Re: ACTION RE: PETITION FROM HIGHLAND VENTURES – REQUESTING SITE PLAN AND DESIGN REVIEW FOR THE ADDITION AND THE REMODEL PROJECT OF THE PROPOSED DOLLAR GENERAL LOCATED AT 3921 S. WEBSTER AVENUE, PARCEL AL- AL-1724-4-1 (current vacant Family Video property)

Date: 20 April 2023

Site Plan & Design Review – Staff Comments

L1.0

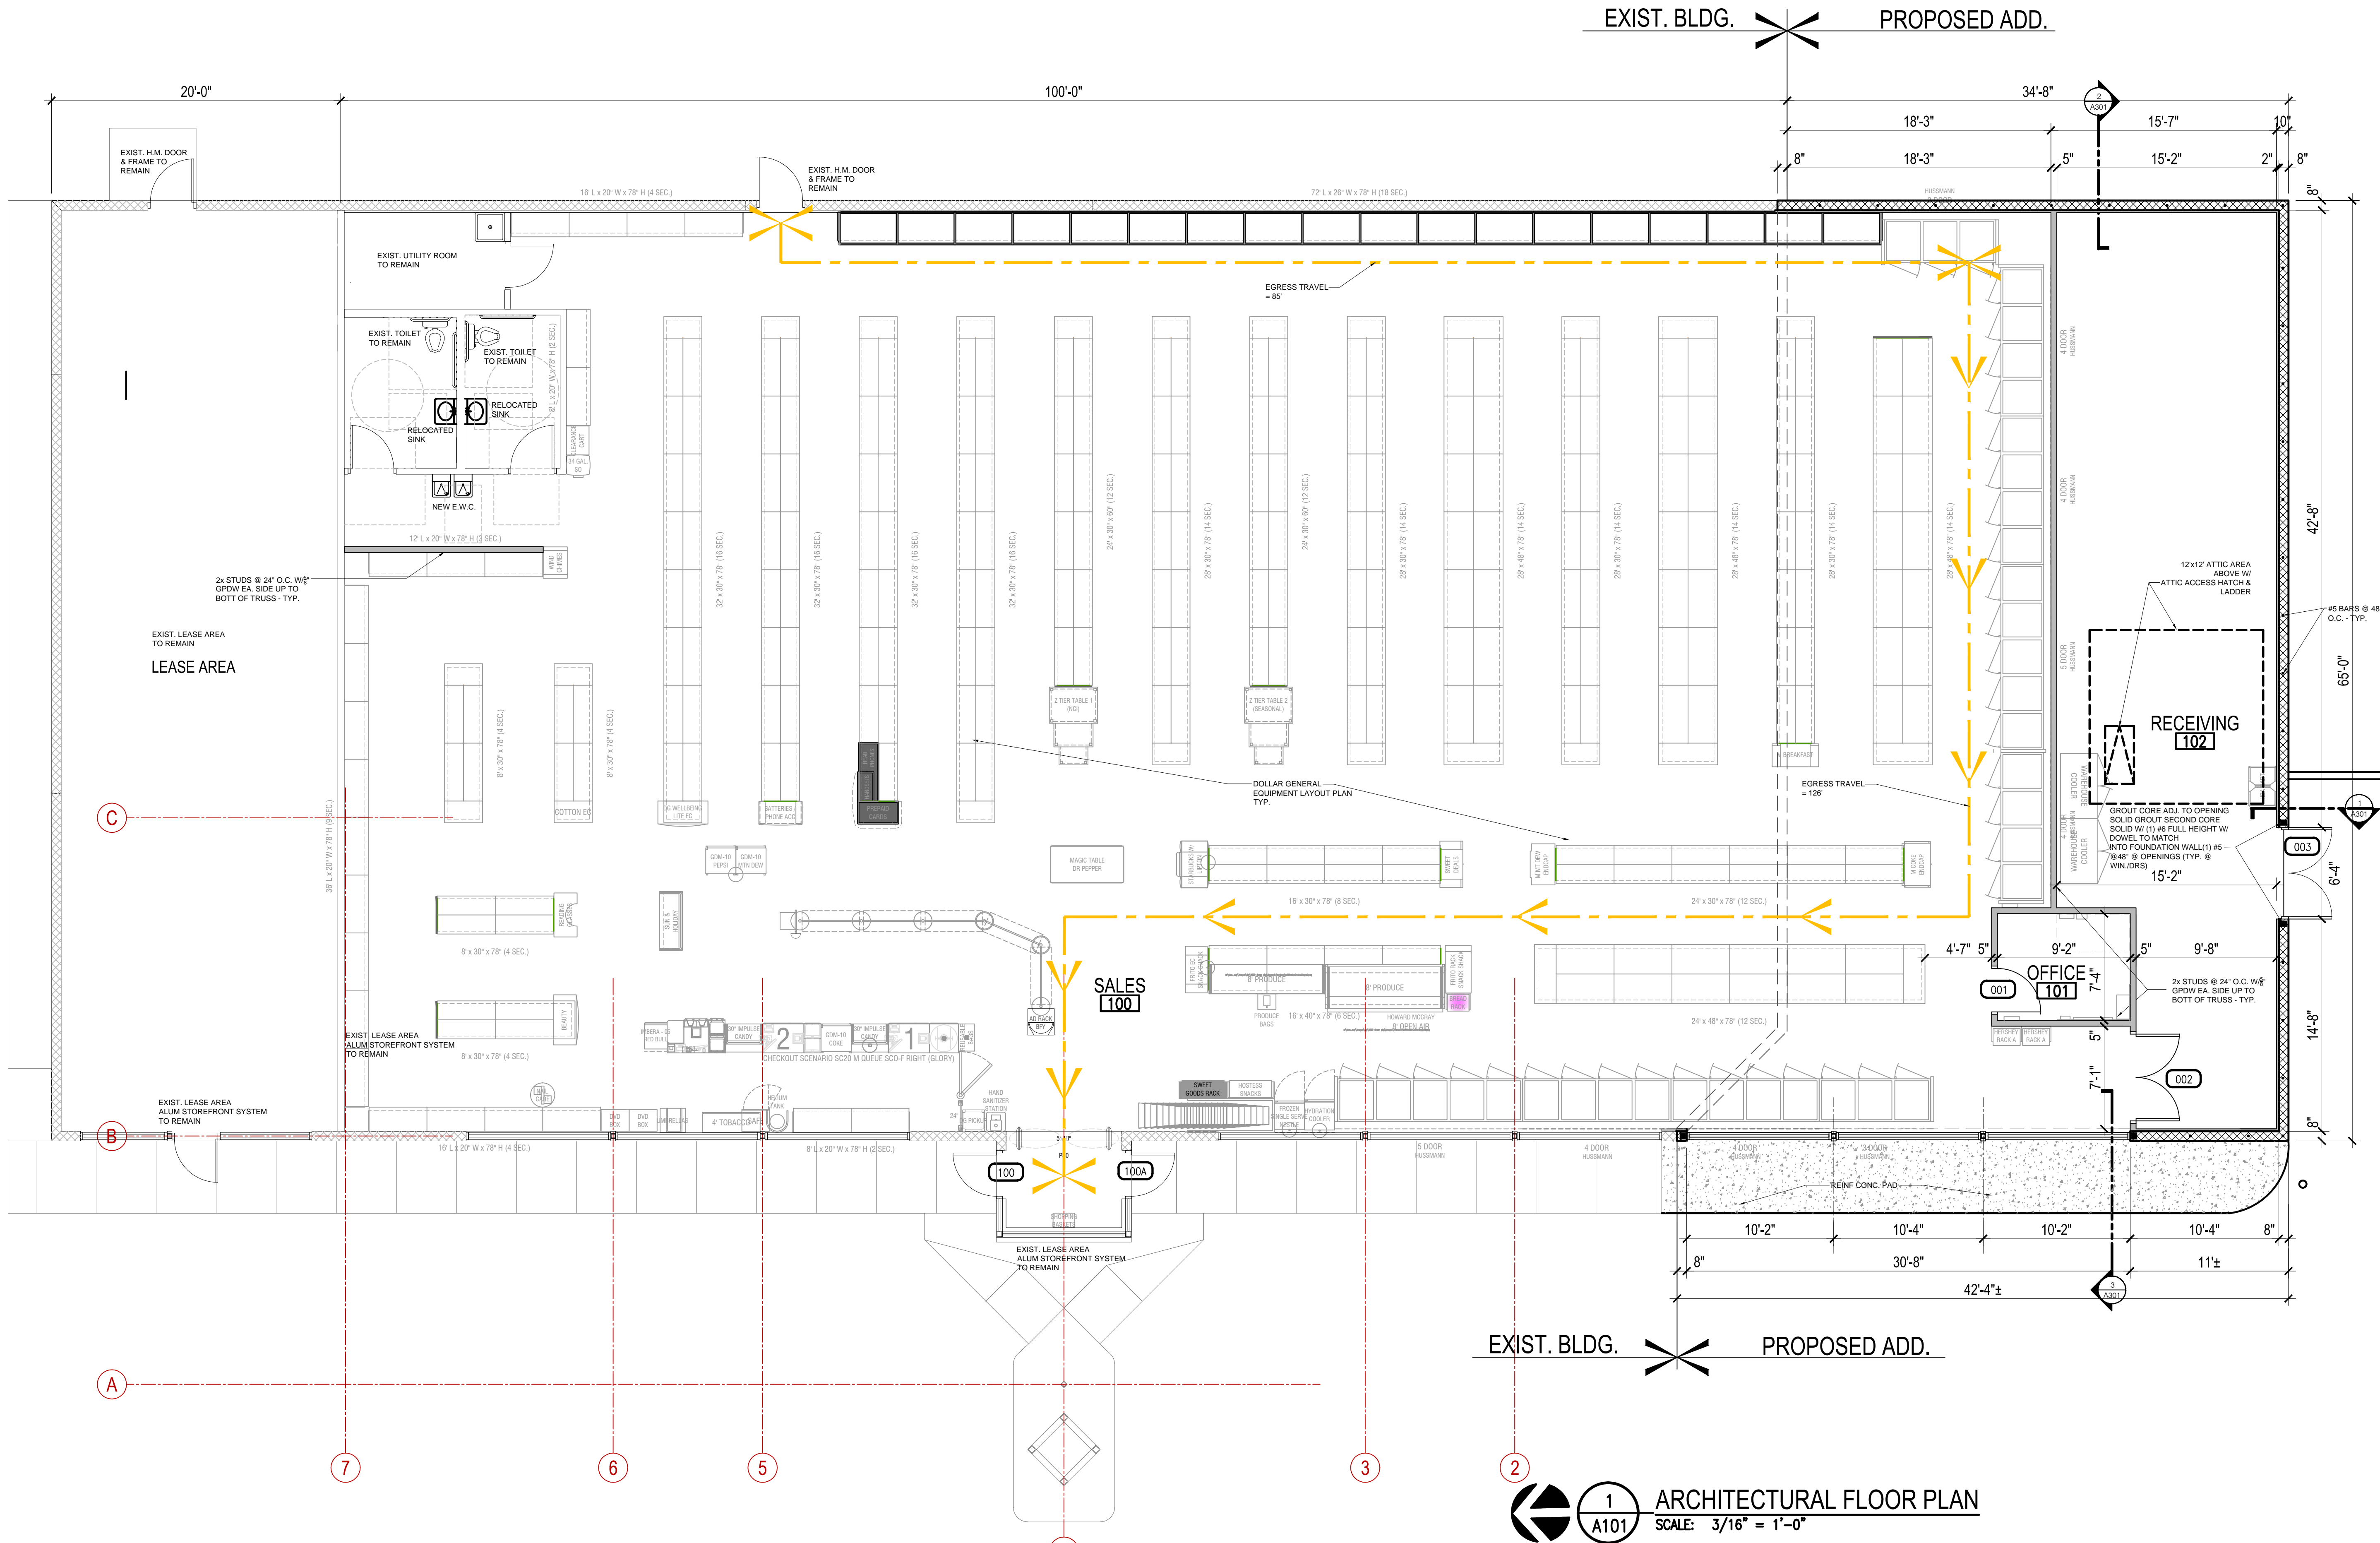
Bicycle	Short-term – 1/5,000SF (3)	Not provided	A bicycle rack which accommodates a U-shaped lock and the ability to secure the bike frame and both wheels for staff use. Must be within 70' of building entrance. Also maintain the rack out of the pedestrian zone. See Section 475-804(C)(1) .
Access	Automobile	Existing	N/A	
	Pedestrian	ADA compliant sidewalks	Standards not met	Parked vehicles should not overhang so as to make the sidewalk less than 5' wide.

Building Articulation	Existing	N/A	
	Building Entrance	1 entrance required per every 60' of building frontage on street facing sides	Standards not met	
Lighting		Dark sky compliant, no light directed towards ROW, no more than 0.5FC at commercial property line and 0.2FC at residential property line; lights must be shut off at 10p.m. if business is closed; light color cannot be greater than 3,000 Kelvin	Standards not met	Please provide lighting plan.
Sign		N/A	N/A	Location should be identified, but design is reviewed at time of sign permit. Sign should be shut off at 10p.m. with lights. One wall sign allowed per business. Must meet all other sign requirements.
Fences/Screening		Existing	N/A	
Landscaping		1 Large shade tree per 50' of street frontage or 1 small tree per 30' for areas with overhead utilities – trees do not need to be evenly spaced, but cannot have a spacing greater than 75'; 1 large shade per every 10 parking stalls	Standards not met	Please provide landscape plan. 14 trees required: 415' of street frontage = 9 trees 49 parking stalls = 5 trees Credits for existing trees can be achieved. See Section 475-903(H)(4) . Parking lot tree requirements. See Section 475-903(F) . No more than 35% of the trees can be of the same species.
